Attachment A: ODNR Permit Review Summary

4. Muskingum Co., Union Twp. 1960 Well Services #1 C. Goff
 - Surface casing and amount of cement appears adequate. The type of cement, and number and location of centralizers used on the surface casing should be specified. Lack of this information limits our review.

Muskingum County, Union Twp., SWIW #27
Goff SWD #1

WELL BORE DESIGN

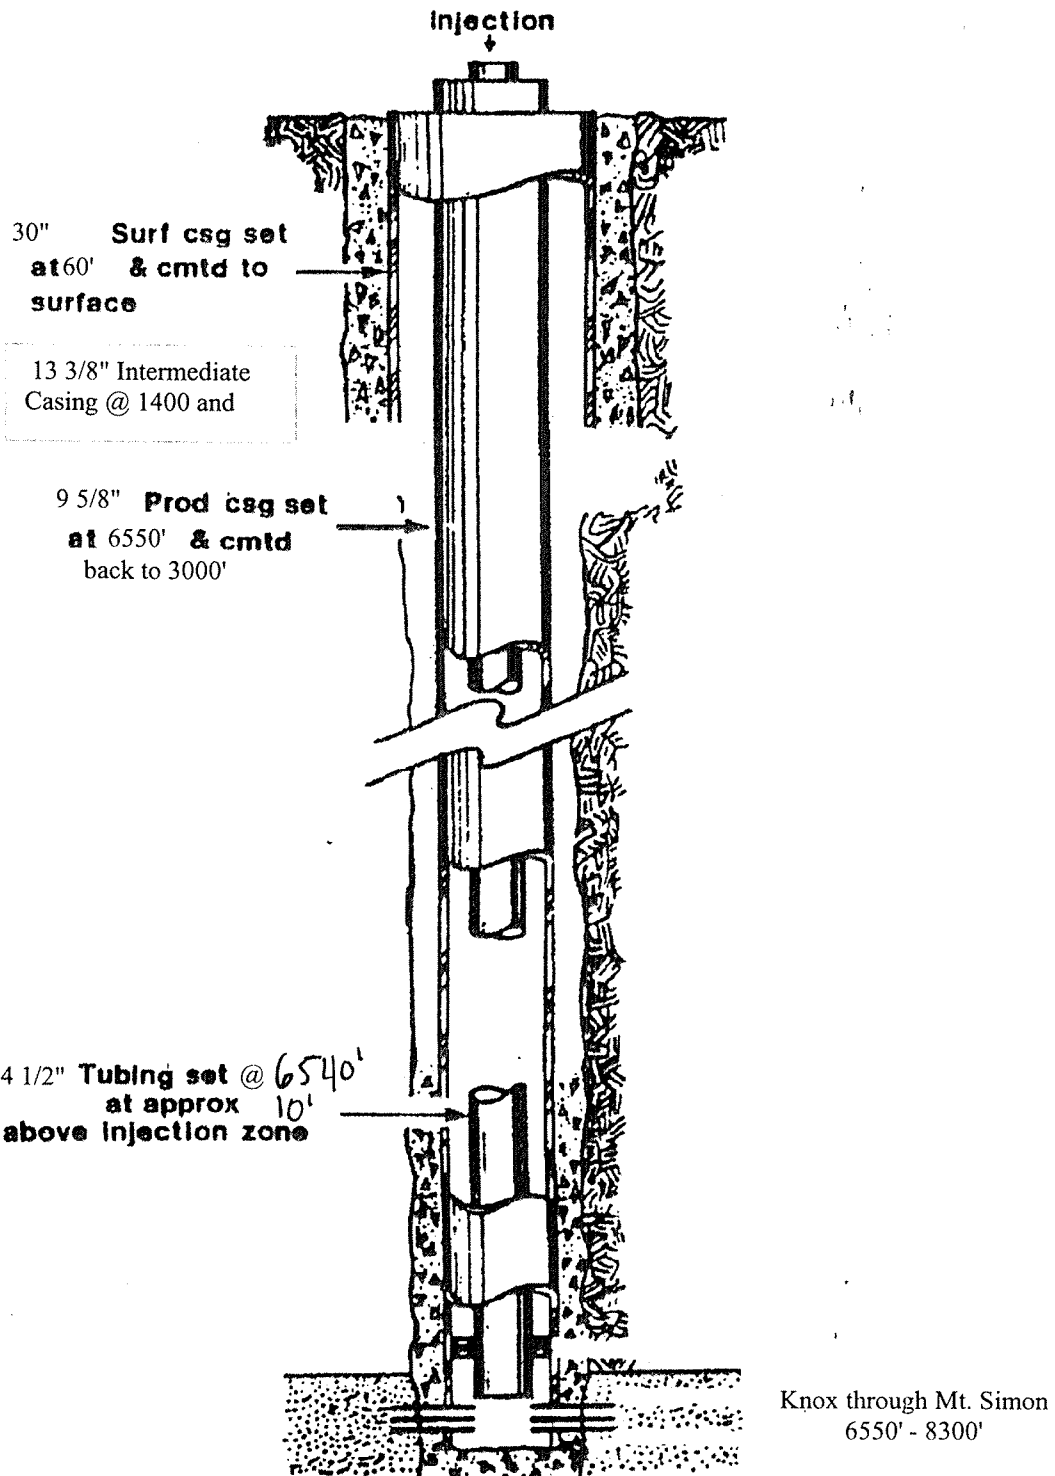
- The injection zone is the Knox through the Mt. Simon; however, completion schematic shows only the Mt. Simon as perforated. The injection zone perforations should be corrected to reflect the revised injection zone.

PROPOSED BRINE WATER INJECTION WELL PLAT
 UNION TOWNSHIP, MUSKINGUM COUNTY, OHIO
 1960 WELL SERVICES, LLC
 300 CHERRINGTON PARKWAY, SUITE 200
 CORAOPOLIS, PA 15108

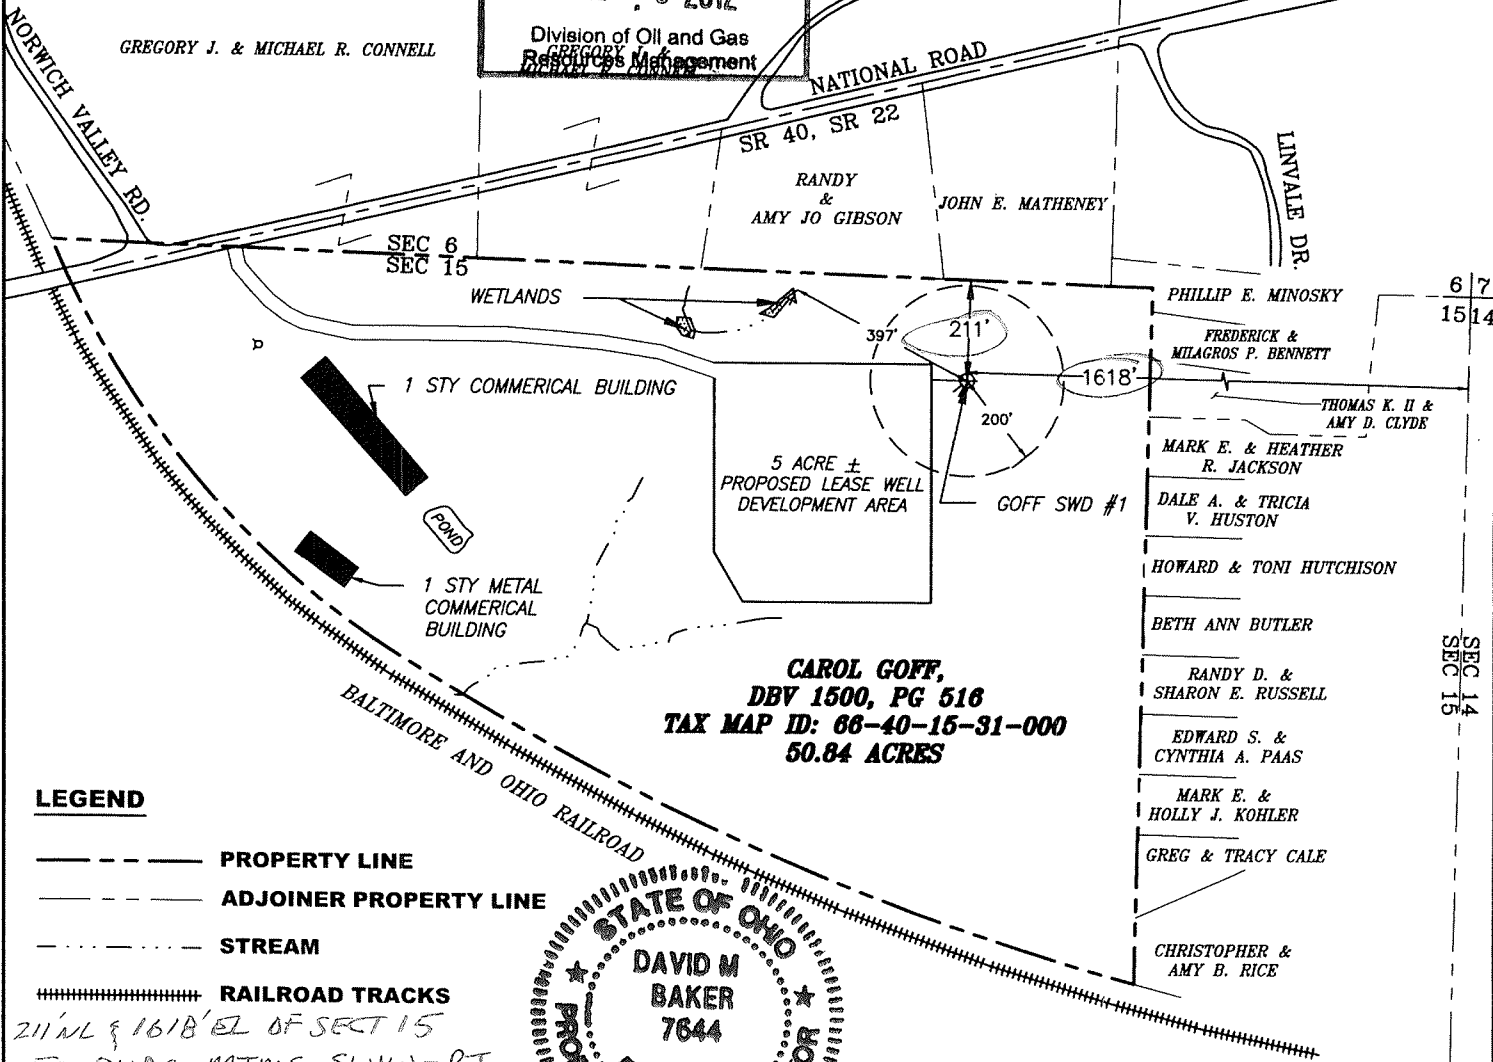
- The plat map shows two small wetland areas that are adjacent to the well and offloading pad. The permittee should be made aware of associated regulatory requirements.
